*Kahaluu Stream Slope
Repair at Hakuhale St.*

Subject: Kahaluu Stream Slope Repair at Hakuhale Street

FINAL ENVIRONMENTAL ASSESSMENT

APPENDIX E
COMMENTS

**COMMUNITY-PANEL NUMBER
150001 0055 B**

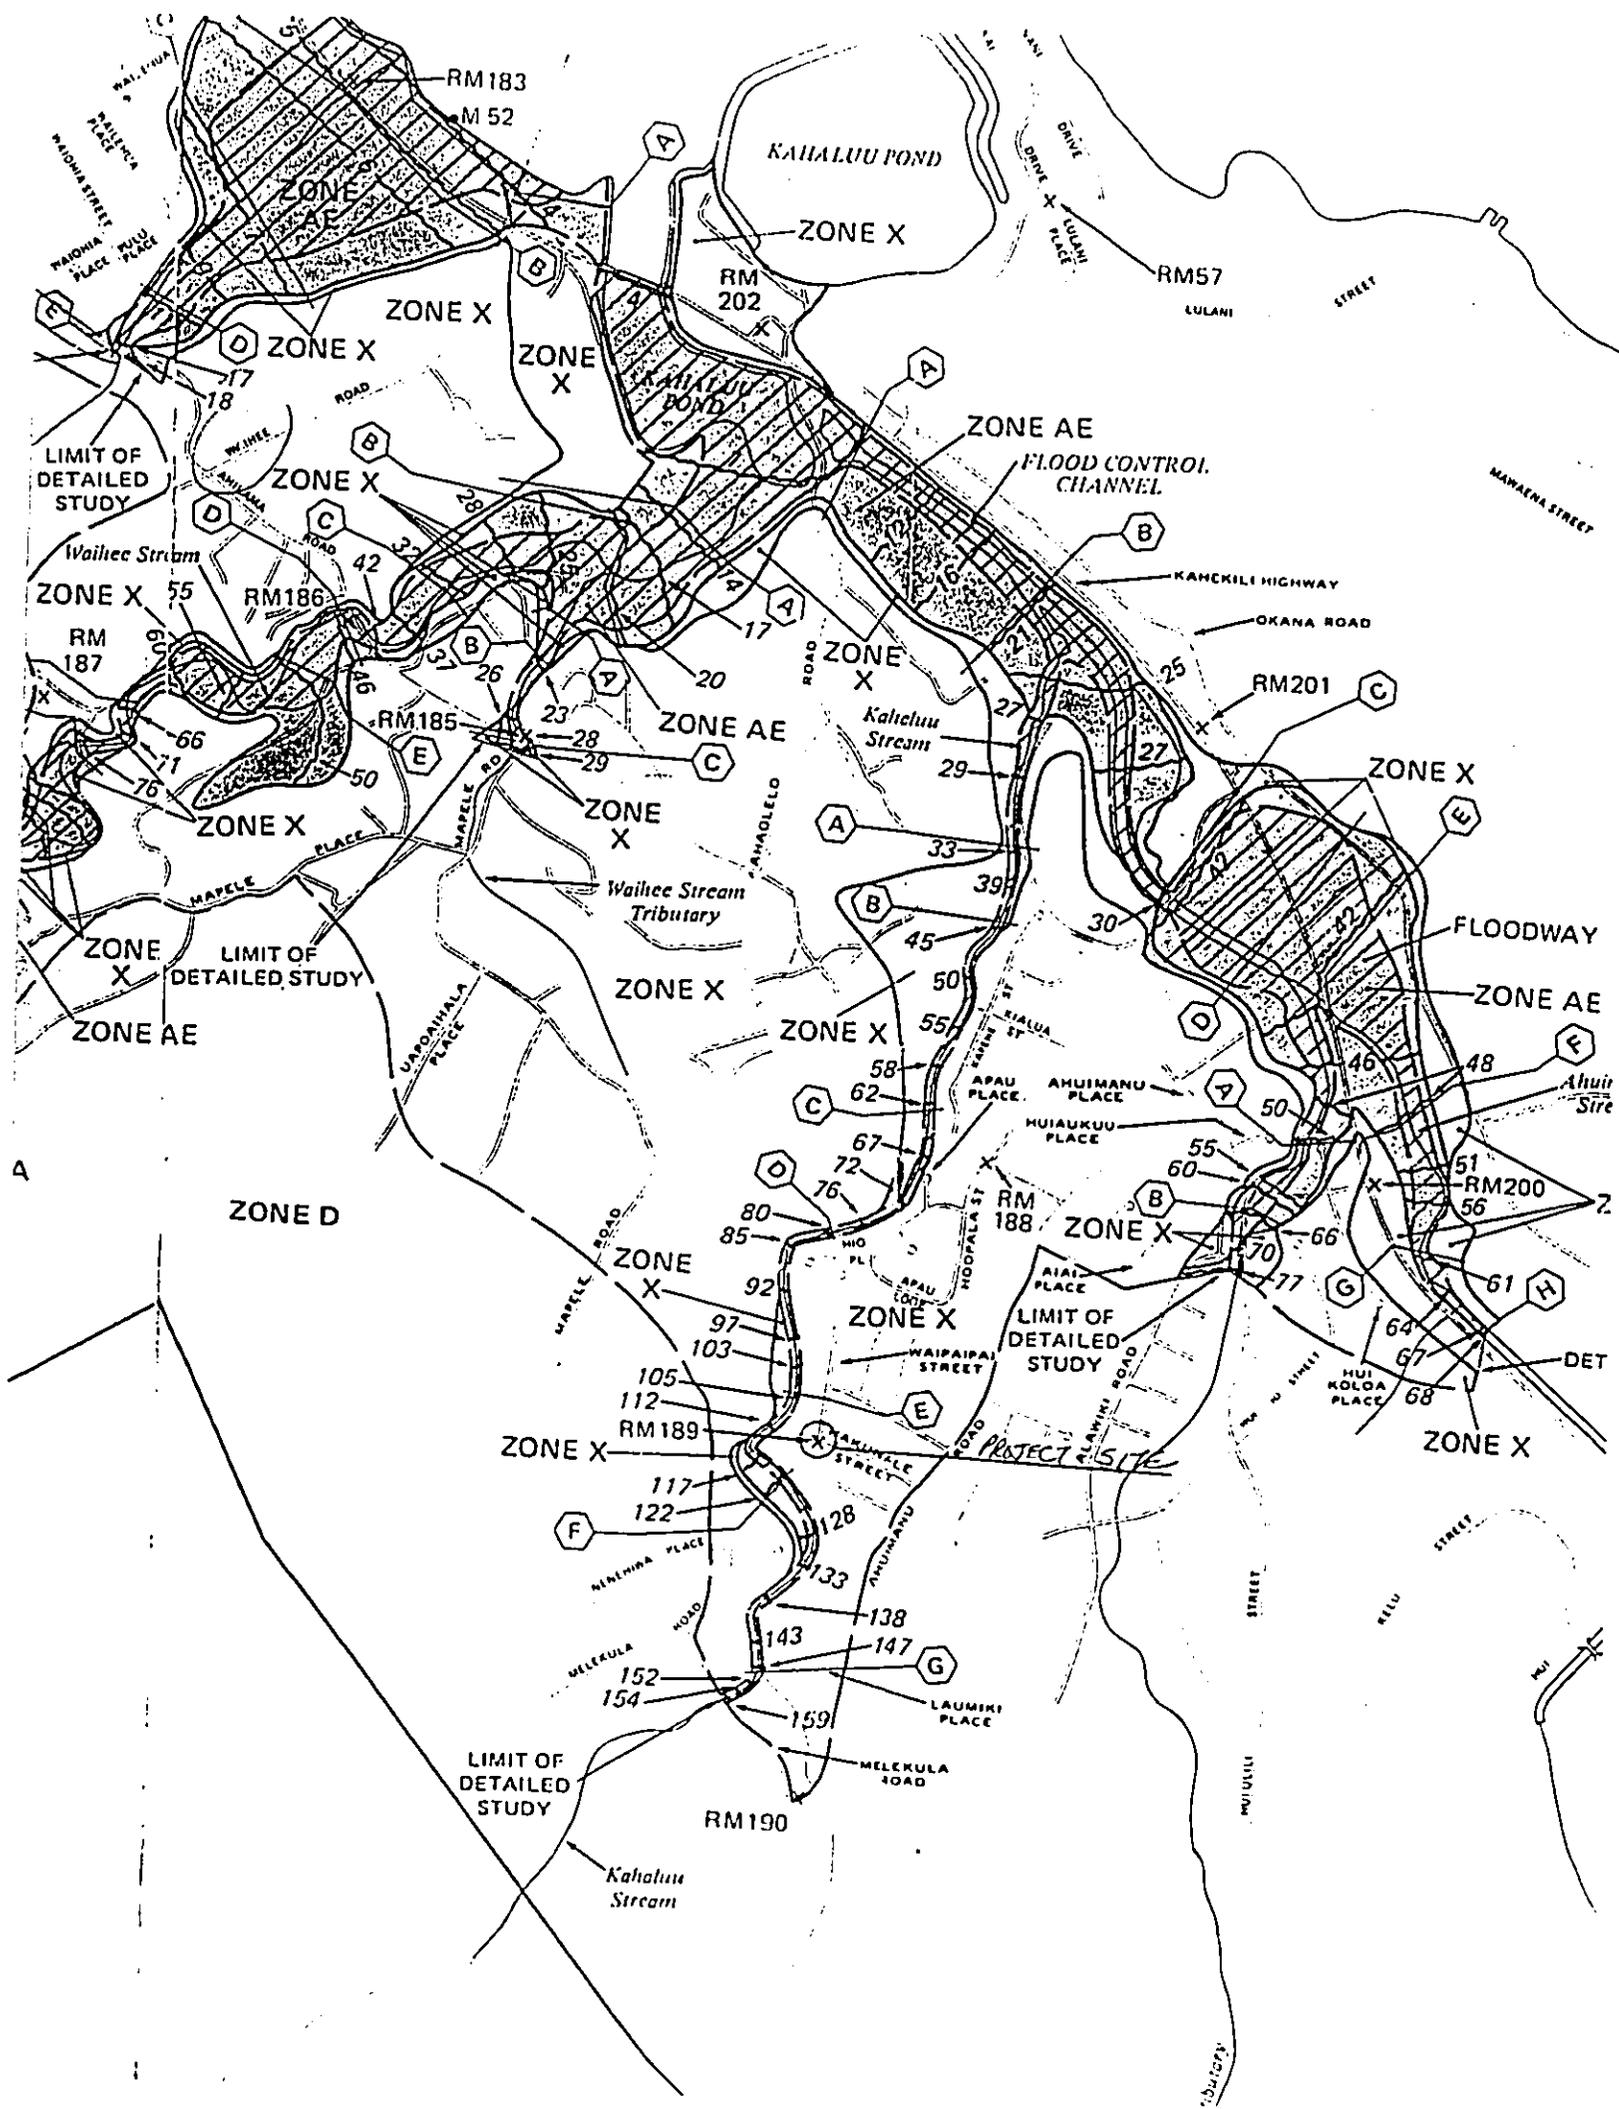
b. According to the enclosed Federal Emergency Management Agency's Flood Insurance Rate Map, panel number 150001 0055B (dated September 4, 1987), the project site is located in Zone X (unshaded; areas determined to be outside of the 500-year floodplain). For further information regarding the flood zone designations, please contact Ms. Jessie Dobinchick of our Technical Analysis Section at 438-7006.

Your thoughtful and timely response was greatly appreciated. We will be filing an application for a Department of the Army permit prior to construction. The information provided regarding the designation of the project area on the FEMA Flood Insurance Rate Map has been included in the final EA.
